## 9. Alternative low cost, long distance physical media dependent layer-- CAT5 UTP

### 9. Category 5 UTP physical medium dependent layer

Figure 9-4—Example equalizer circuit (informative)

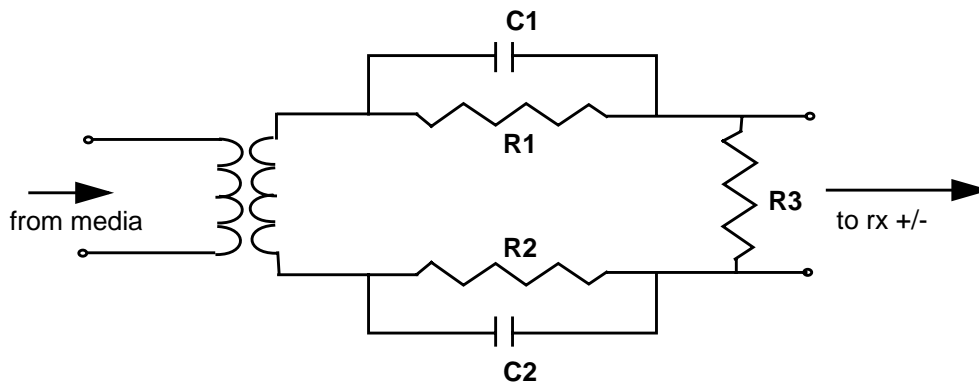
5 A fixed equalizer can be used to provide sufficient equalization for a 1394B CAT 5 cable. An example of an equalizer circuit  
6 that may be used is shown in [figure 9-4](#). This circuit is a simple high pass filter that boosts the higher frequency  
7 components of the CAT 5 PMD in order to generate a sufficient decision window in the eye diagram at the output of the  
8 receive network (TP4). Examples of eye diagrams at the input [and output](#) and [output](#) of this equalizer circuit are shown in  
9 [figure 9-5](#).
